# UNITED STATES PATENT AND TRADEMARK OFFICE

APPLICATION NO.	FILING DATE	FIRST NAMED INVENTOR	ATTORNEY DOCKET NO.	CONFIRMATION NO.
10/059,176	01/31/2002	Hirokazu Hayashi	OKI.298	7695
20987	7590	08/24/2006	EXAMINER	
VOLENTINE FRANCOS, & WHITT PLLC ONE FREEDOM SQUARE 11951 FREEDOM DRIVE SUITE 1260 RESTON, VA 20190			SAXENA, AKASH	
			ART UNIT	PAPER NUMBER
			2128

<b>Office Action Summary</b>	<b>Application No.</b>	<b>Applicant(s)</b>
	10/059,176	HAYASHI, HIROKAZU
	<b>Examiner</b>	<b>Art Unit</b>
	Akash Saxena	2128

**DETAILED ACTION**

Fig. 1: MOSFET with both vertical and horizontal non-uniform doping profiles.

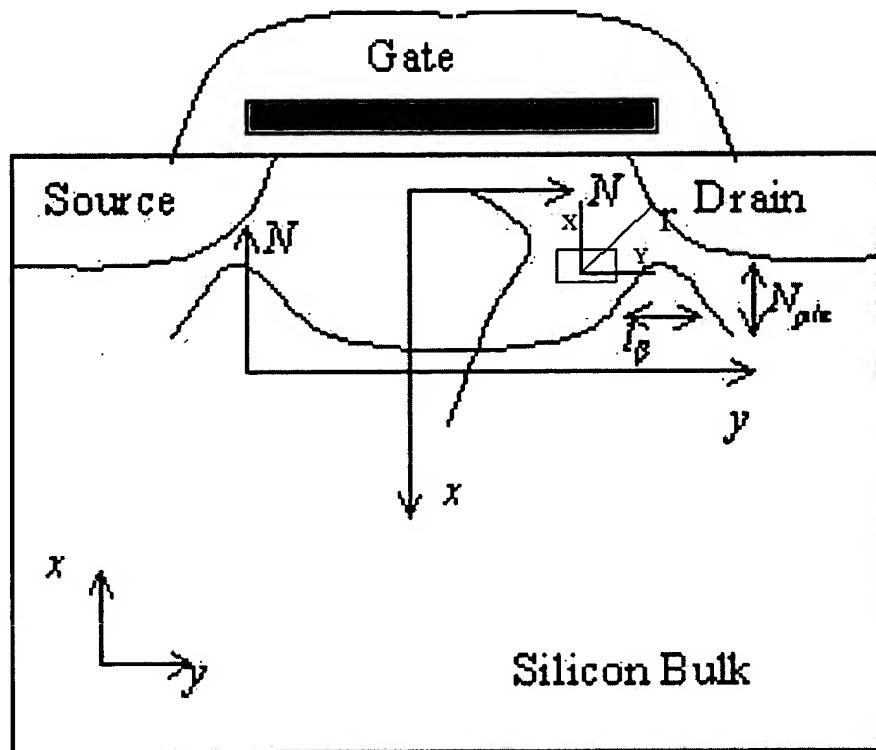
LI'1999 reference was used to teach the above-mentioned limitation. LI1999 not only teaches setting data of a position of a source or a drain (LI1999: See Fig.1), but also teaches functionally identical determination of the amount of impurity in each of the cells as an impurity density function of distance  $r_1$  and  $r_2$  related to drain and source, as featured in claim 1 (LI'1999: See Fig.1 impurity distribution (N) in x and y direction).

To this effect, examiner admits the distribution is not disclosed in terms of  $r_1$  and  $r_2$  as featured in the claim, however if the impurity density function in x and y domain is given in view of source and drain then impurity density can be determined at any position in the mesh. Mere transformation of the co-ordinate system is a mathematical manipulation of the already available density function. See examiner's

illustration below where  $r$  ( $r_1$  or  $r_2$ ) can be expressed in for on X & Y position and the impurity distribution  $N$  is presented with respect to X & Y.

Further, applicant has argued that the two distances  $r_1$  and  $r_2$  were used to arrive at the impurity density. Again, this is just a mathematical representation as illustrated below.

$r_1 = (x_1, y_1)$  (distance  $r_1$  can be decomposed in form of  $x_1$  and  $y_1$  in X & Y co-ordinate system as presented in LI'1999 Fig 1). Similarly  $r_2 = (x_2, y_2)$ . Adding X and Y components yields exact x and y positions in the X-Y co-ordinate systems, i.e.  $x = x_1 + x_2$ ;  $y = y_1 + y_2$  and provided the graphs of X-vs-N (X position verses Impurity density function graphs in fig 1) and Y-vs-N (Y position verses Impurity density function graphs in fig 1) one can mathematically compute the impurity density at any point relative to the distance  $r_1$  and  $r_2$ .
